Model: C500/C750	May 14, 2025
Serial #: N/A	
Product Bulletin # TDS-267 Rev 1

C500/C750 Cage Reinforcement

Figure 1: Areas where cracks could possibly develop

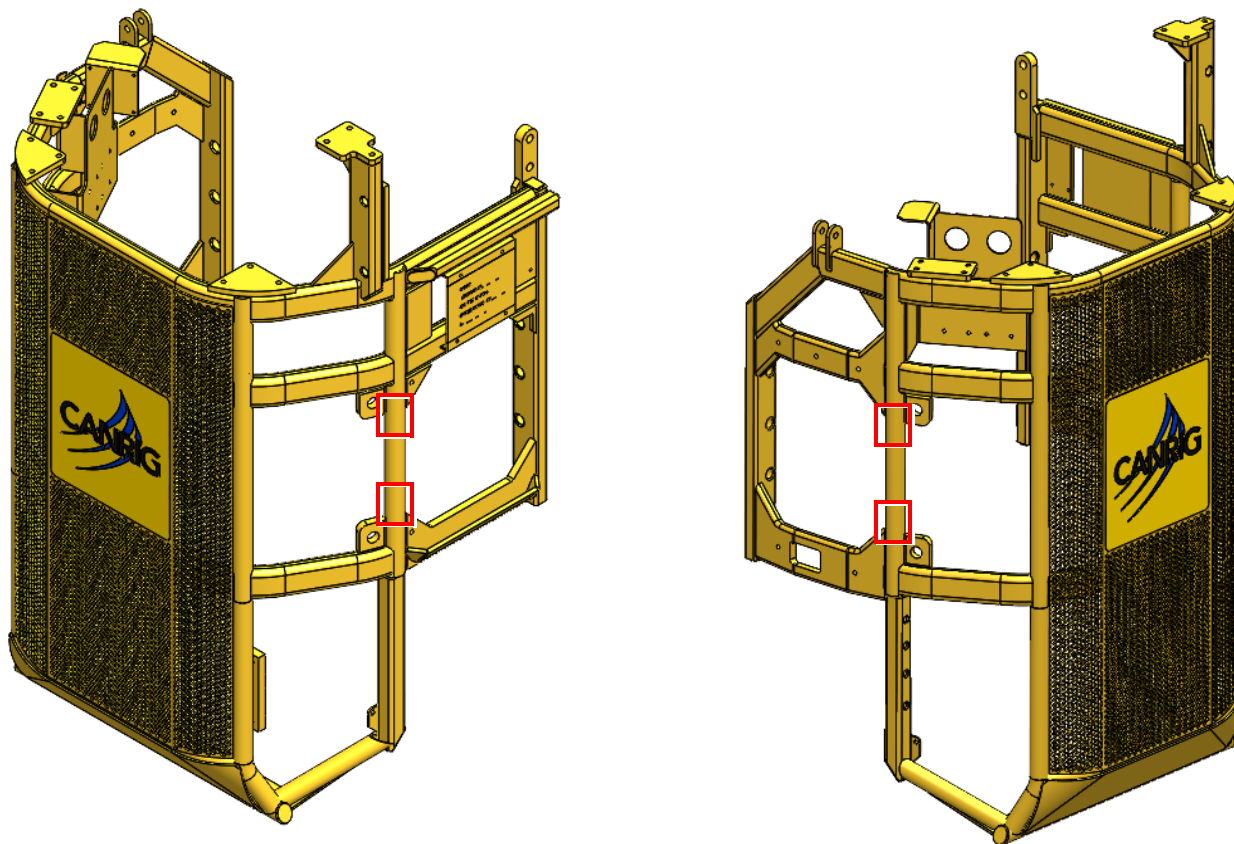
There have been reports of possible cracking in areas of Top Drive Cage weldments.

A visual inspection is recommended to ensure no cracks are present on the TD Cage. Refer to areas shown in Figure 1 on page 2. If no cracks are found, continue to monitor these areas during routine inspections as a precaution.

If cracks are found in these areas of the Cage, follow steps below to perform the repair.

Figure 7: Plates installed on cage (DS)

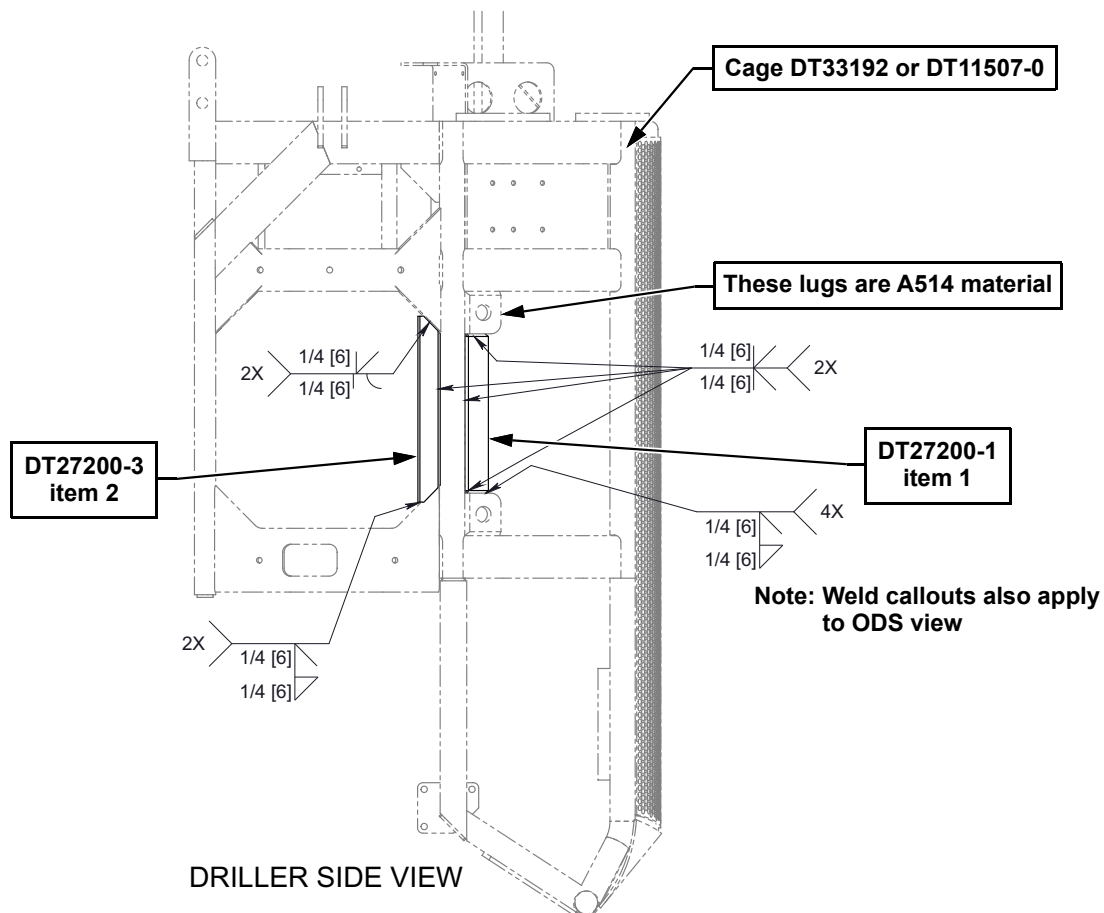
1. Weld item DT27200-1 (item 1) and DT27200-3 (item 2) to the DS of the cage as shown in Figure 7. **Note:** Outside of items 1 and 2 are flush with outside of plate/HSS above and below them.

Welding Procedure Specification (WPS) required for all welds. Note that lifting lugs above and below item 1 are ASTM A514 material.

Figure 8: Triangular gusset to be removed.

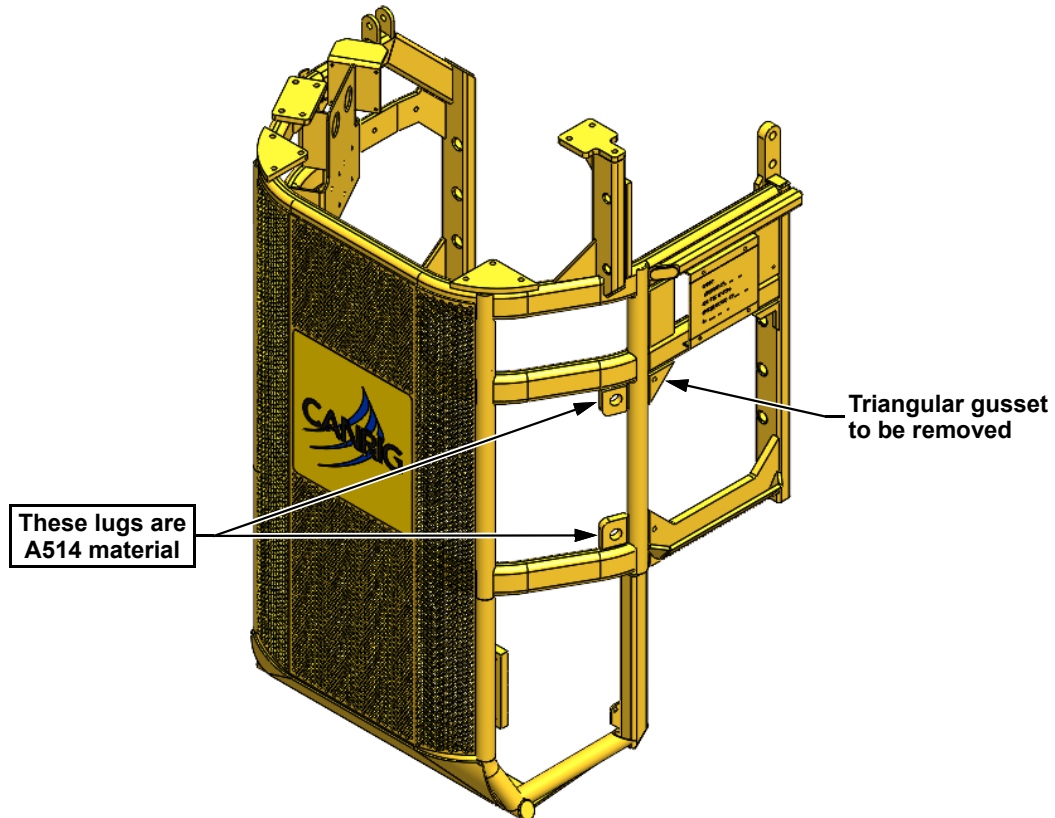
- If the cage is **Rev D** (Ref. Drawing DT33192), then the bottom ODS beam will be 1" plate.
1. Remove existing 4" x 4" x 1/2" triangular gusset (See Figure 8) on the top ODS.

Figure 9: Plates installed on cage (ODS)

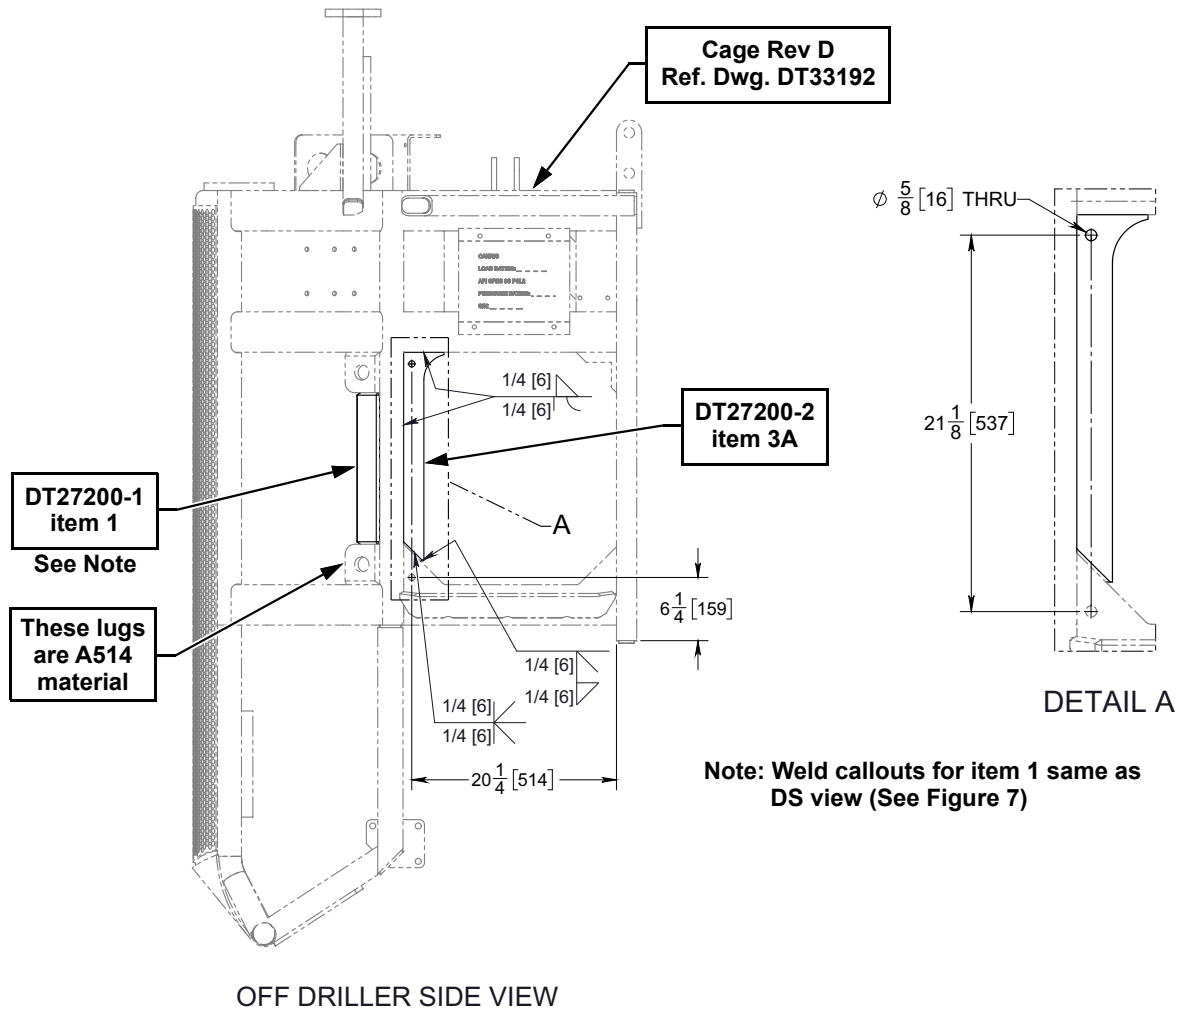
2. Replace with plate P/N: DT27200-2 (item 3A) as shown in Figure 9. **Note:** Outside of items 1 and 3A are flush with outside of plate/HSS above and below them.
3. Drill $\frac{5}{8}$ " hole as shown in Detail A in Figure 9.

Welding Procedure Specification (WPS) required for all welds. Note that lifting lugs above and below item 1 are ASTM A514 material.

Figure 10: Triangular gussets to be removed.

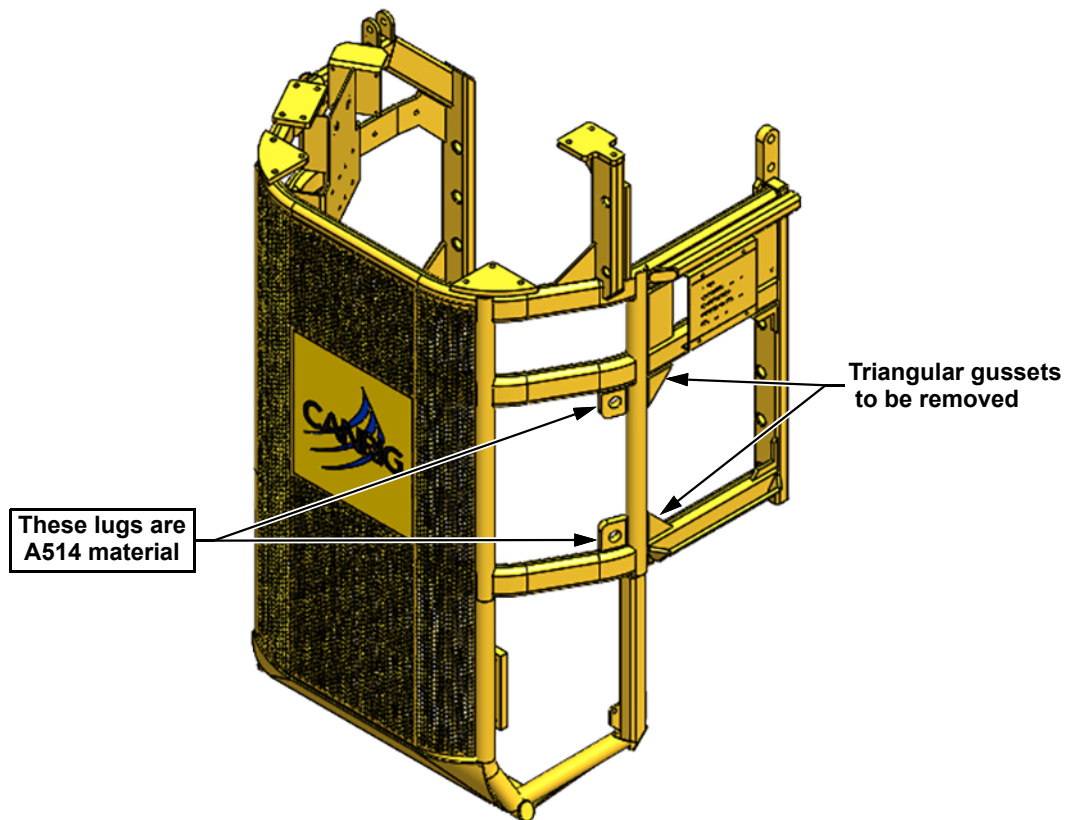
- If the cage is DT33192 **Rev A, B, or C** or DT11507, then the bottom ODS beam will be 4" X 2" HSS with a 4" x 4" x 1/2" triangular gusset (See Figure 10) at its junction with the vertical pipe. In this case, one (1) of plate P/N: DT27200-4 (item 3B) is required.
1. Remove the existing 4" x 4" x 1/2" triangular gussets on the top and bottom ODS.

Figure 11: Plates installed on cage (ODS)

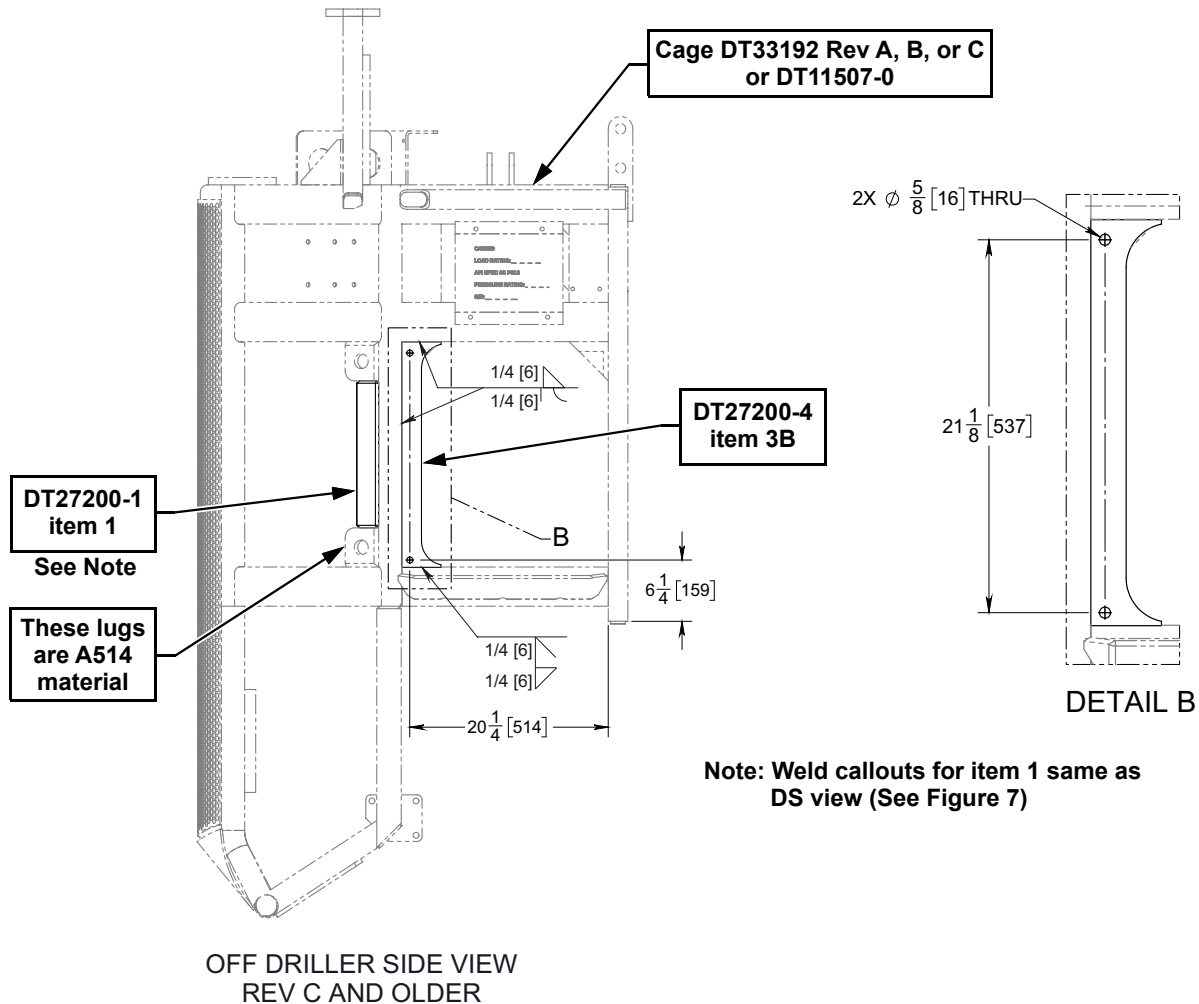
2. Replace with plate P/N: DT27200-4 (item 3B) as shown in Figure 11 on page 12. **Note:** Outside of item 3B is flush with outside of plate/HSS above and below them.
3. Drill 5/8" hole as shown in Detail B in Figure 11.

4. MPI all welds of ASTM A514 material within 48 hours after completion of welding.
5. Protect all machined holes and surfaces prior to blasting and painting.
6. Touch up paint Canrig Yellow (RAL No. 1006 / Maize Yellow).
7. After painting, apply anti-rust protection.
